Re: NOIA Responses – Item 3
Shelby Crushed Stone - Medina Mine Expansion

This letter addresses comment #3 by Mr. Robert Call (NYSDEC) in the February 14, 2020 Notice of Incomplete Application (NOIA) for the referenced site (Mine ID #80346). The comment is provided below, along with our response.

FUTURE MONITORING PLAN FOR WETLAND MD-9

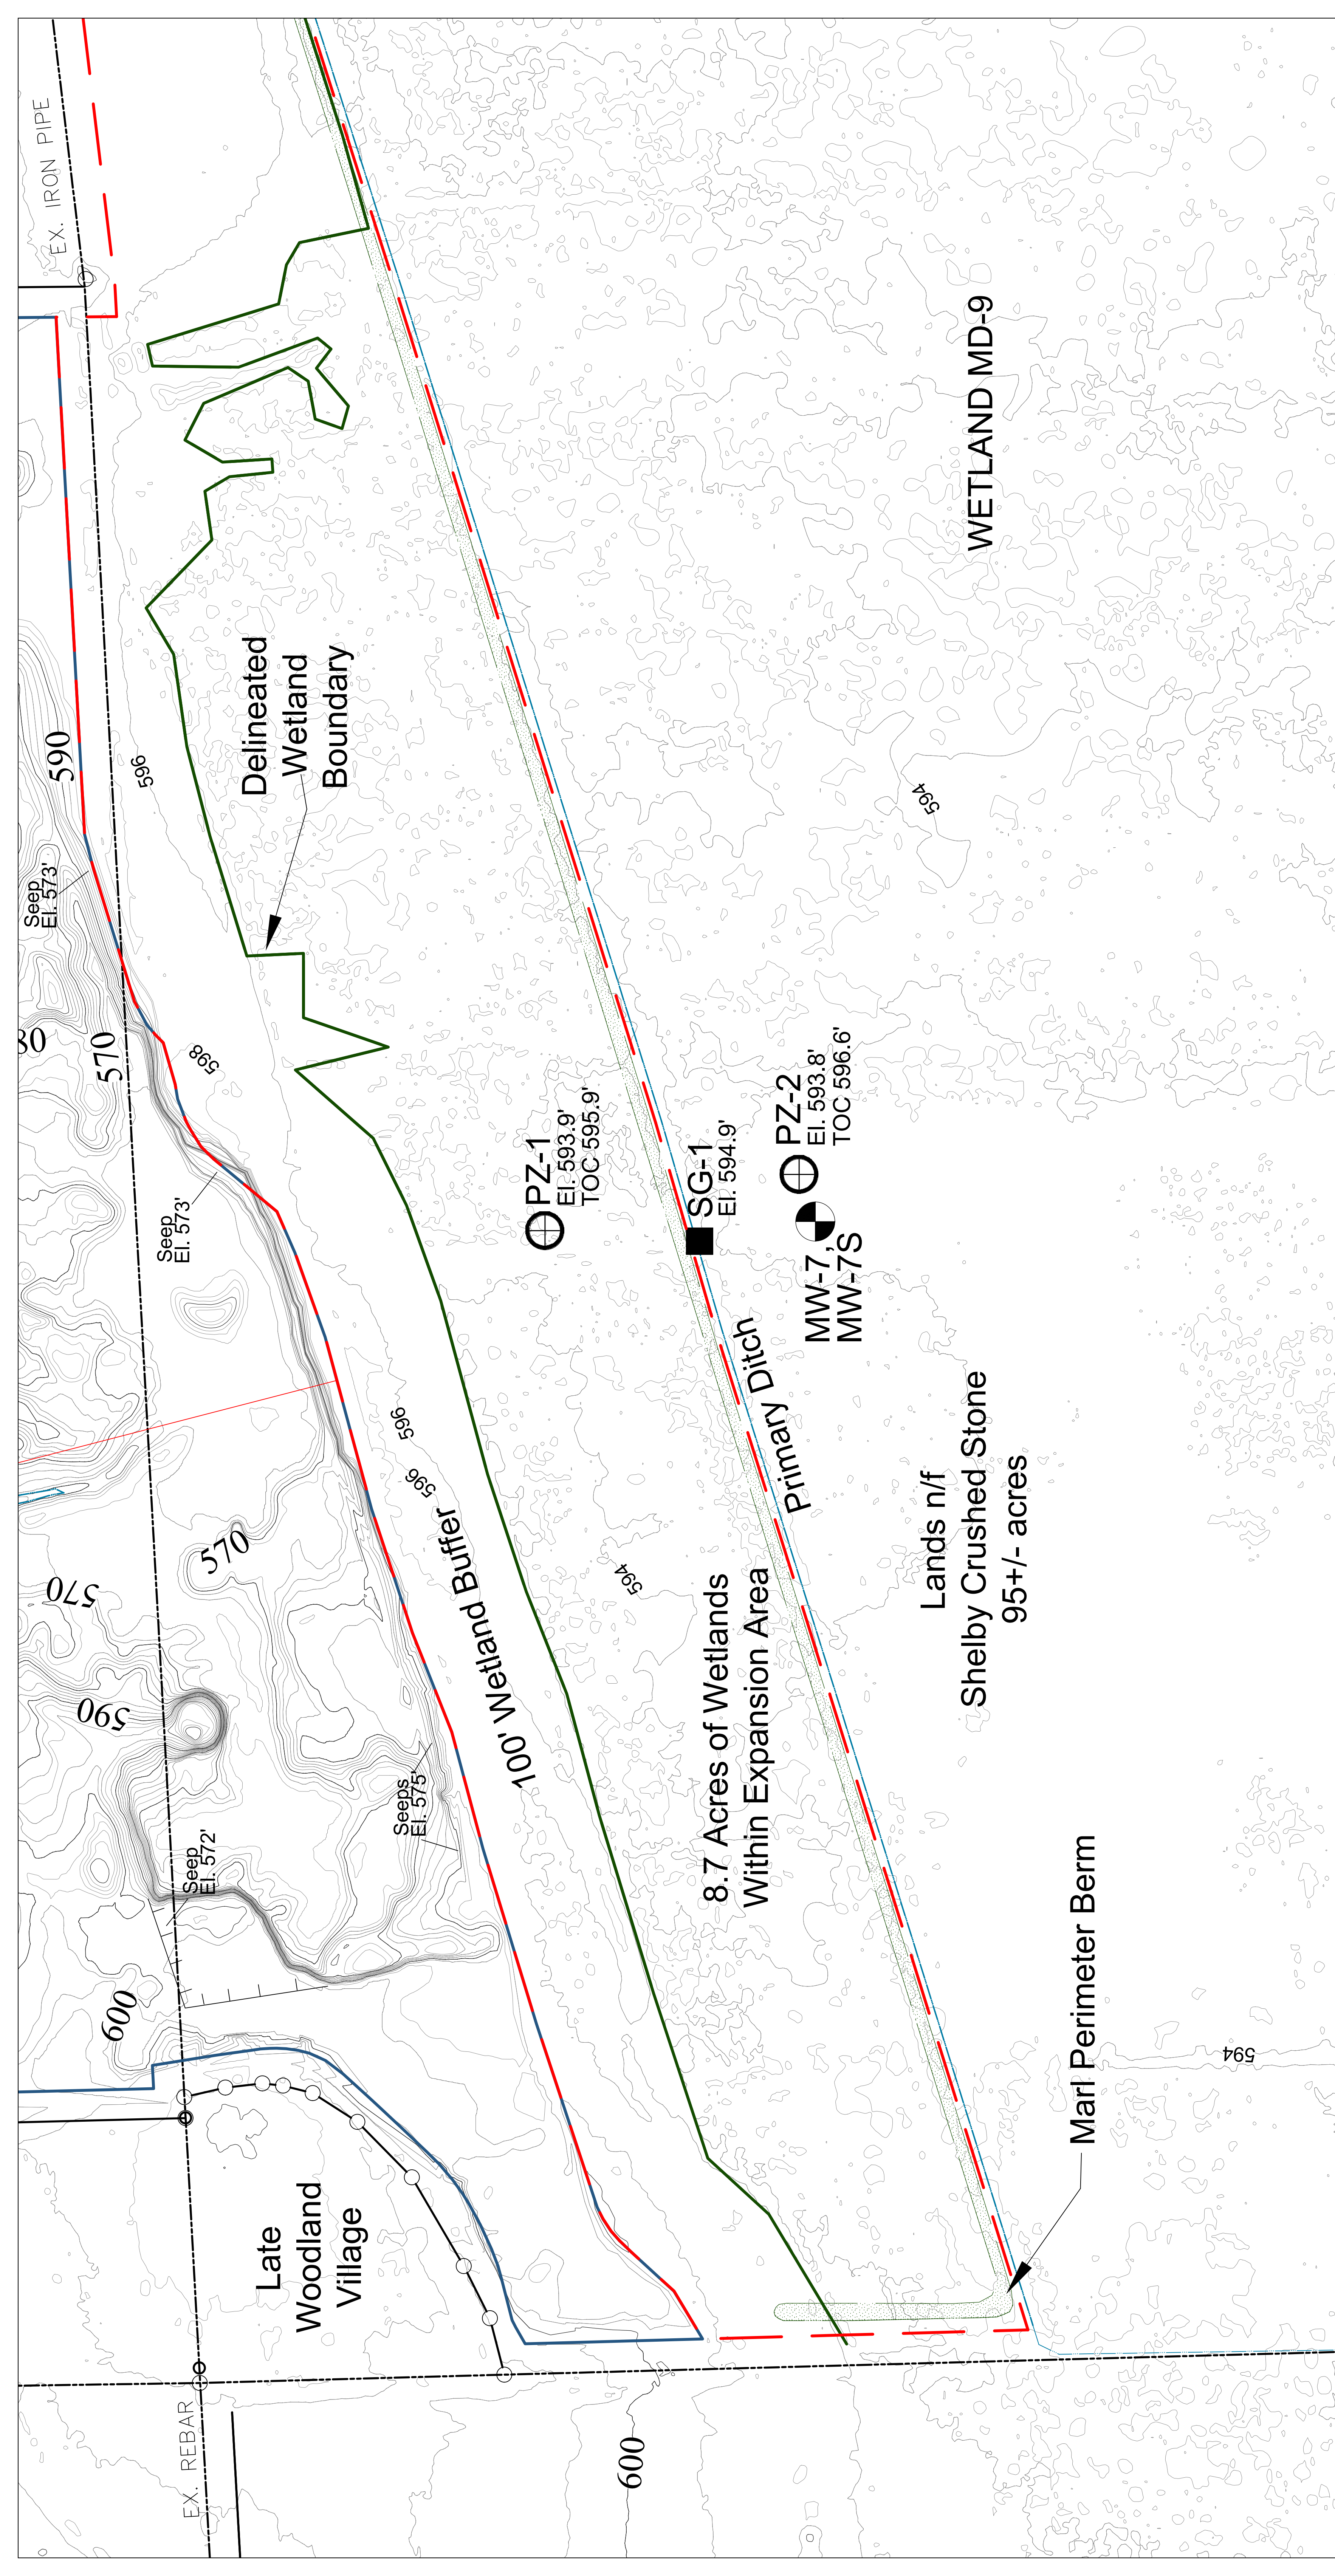
NYSDEC Comment 3: Please provide a future monitoring plan for the wetland, including but not limited to piezometers, wells and staff gauges. The monitoring plan should include a full sized map with all monitoring locations clearly depicted.

The future monitoring plan for the wetland consists of water-level monitoring at existing and new locations in the wetland. Well points PZ-1 and PZ-2, and staff gauge SG-1, will be added to the existing monitoring required by Special Condition #12 of the Mining Permit. The attached figure shows the locations of these monitoring points. PZ-1 is located north of the primary ditch and PZ-2 is located south of the primary ditch. Both well points allow for monitoring of the shallow, semi-perched, seasonal water table. SG-1 is located within the primary ditch and monitors the surface water level in the ditch.

A monitoring well pair will be installed south of the primary ditch in a track-rig accessible area of the wetland at a location preferably near PZ-2. One of the wells will be screened in the unconsolidated material above bedrock (MW-7S), but beneath the lacustrine silt and clay layer. The other well (MW-7) should be completed in bedrock through the Gasport Member and into the Decew Member, with the overburden cased and sealed off with cement. The addition of this monitoring well pair will allow monitoring of the surface water (SG-1); the shallow, perched

system above the silty clay (PZ-1 and PZ-2); the unconsolidated material above bedrock (MW-7S) and the bedrock aquifer (MW-7).

This monitoring plan will allow for observation of water-level impacts that may occur in the future as the mine advances into the 8.7 acres of wetland. Water level measurements at these locations will continue at the monthly frequency already required by Special Condition #12. Monitoring of PZ-1 will cease once mining has advanced to its location.
